The approach to Cambridge

Section D: Clapham Green to The Eversdens

Figure 1 Highfields with Bourn Airfield and Linden Homes Developments

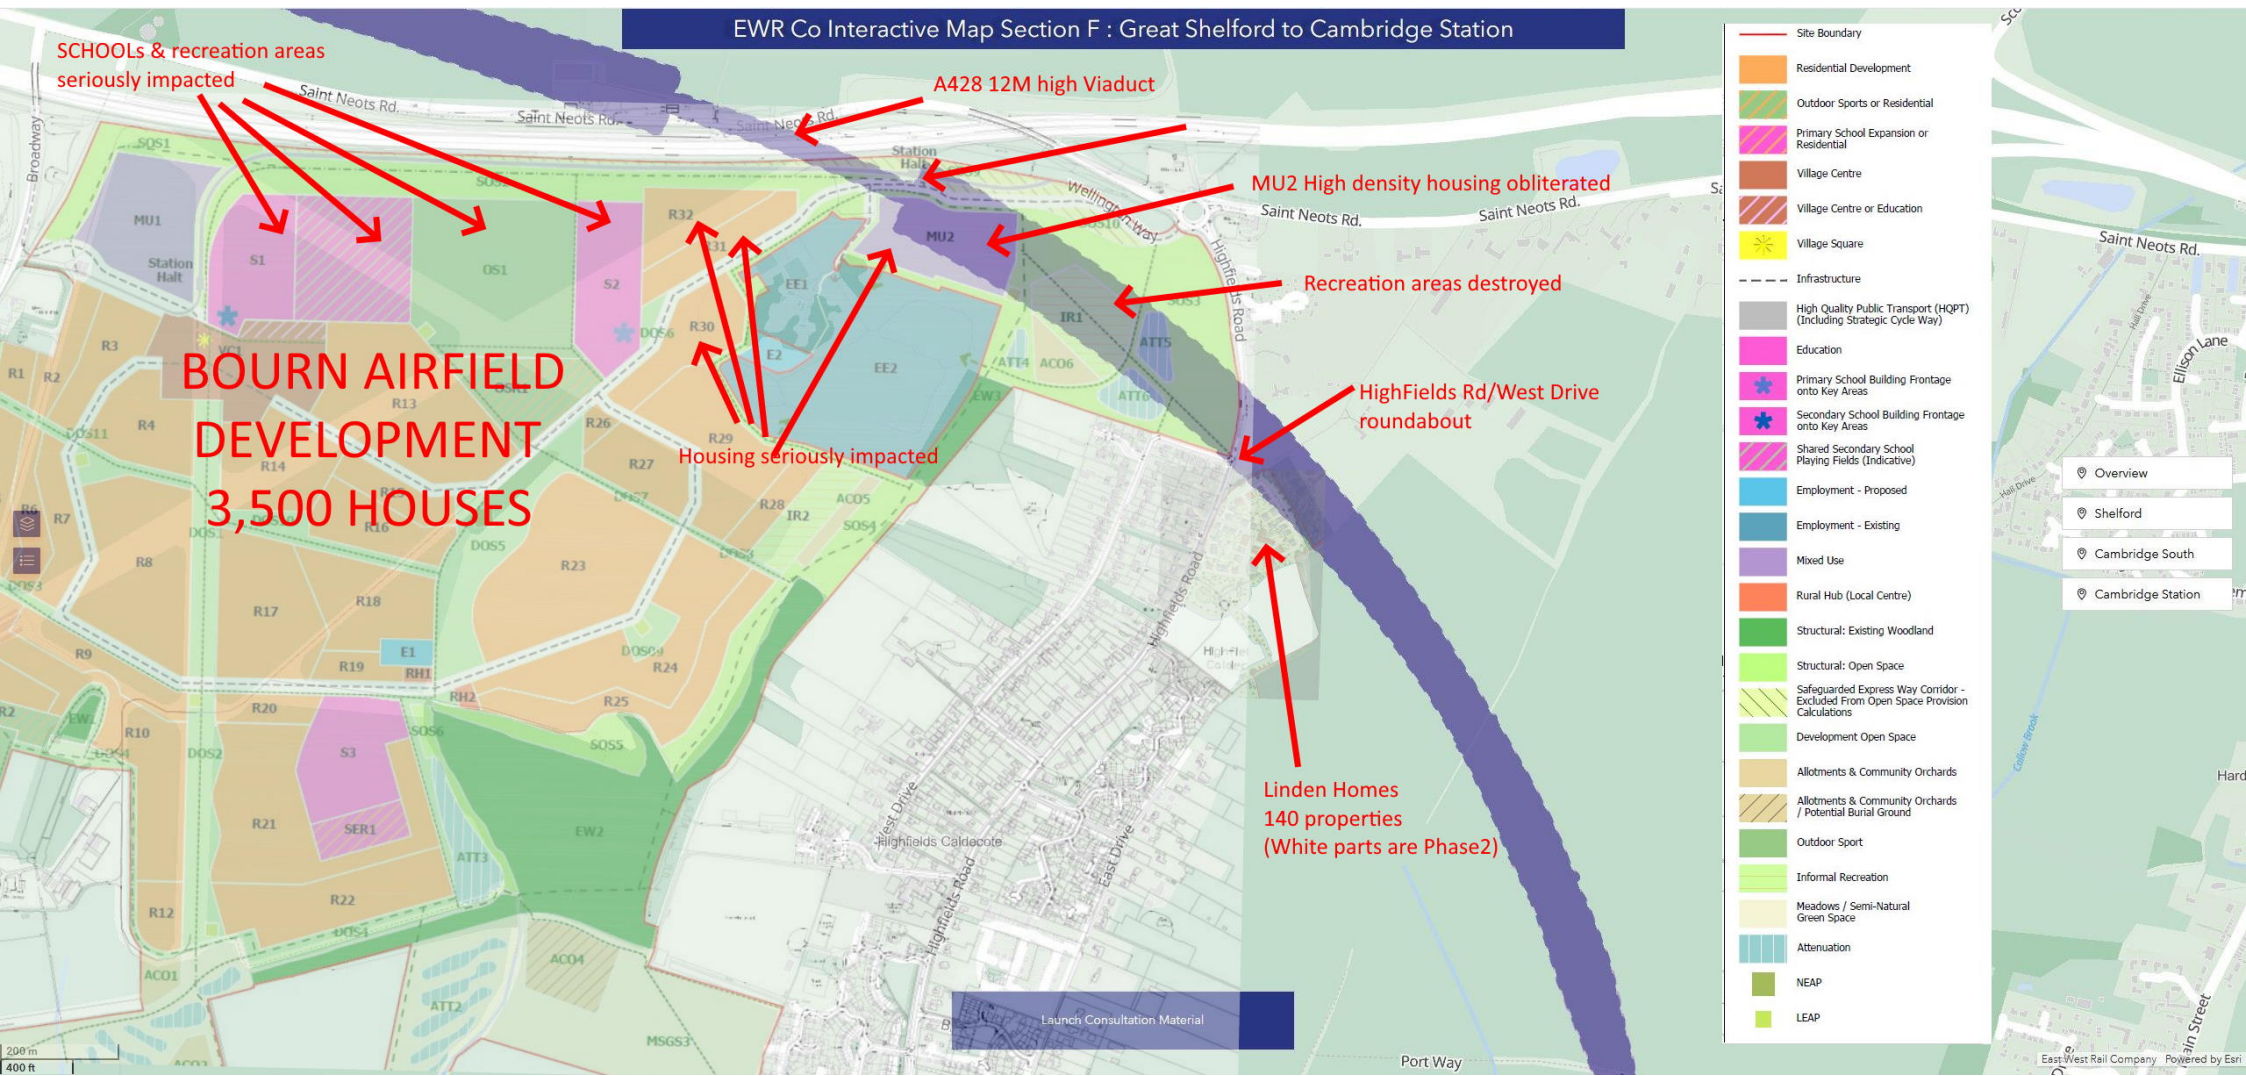
We strongly feel that we cannot recognise the current preferred alignments 1&9. EWRail has failed in their due diligence and duty of care to consider the two developments that are Countryside’s Bourn Airfield development and the Lindens Homes Angel Park development. Figure 1

- 1) EWRail have failed to realise that these alignments sever the top of Highfields Caldecote, separating most of the houses from the Village sign and the residents to the North. Coupled with the spectre of a 10m to 12m viaduct/embankment on top of a hill already higher than most of the surrounding area we feel that the landscape/ townscape of both Highfields and the entrance to the new development at Bourn Airfield are disproportionately impacted, contrary to 5.30.11. Landscape. EWR Co shall protect and enhance the quality of landscapes, townscapes and visual amenity.

- 3) Whilst the alignment may be moved so that no homes are demolished at Angel Park, currently 9+ additional homes, any alignment over, or under the A428 will have a significant impact on the number of homes built on Bourn Airfield. The field at the front is part of this development, offering open space and attenuation ponds for drainage. This is contrary to both 5.30.13. EWR Co shall seek to avoid or minimise residential land acquisition.¹ And 5.30.14. EWR Co shall seek to avoid or minimise the demolition of properties¹
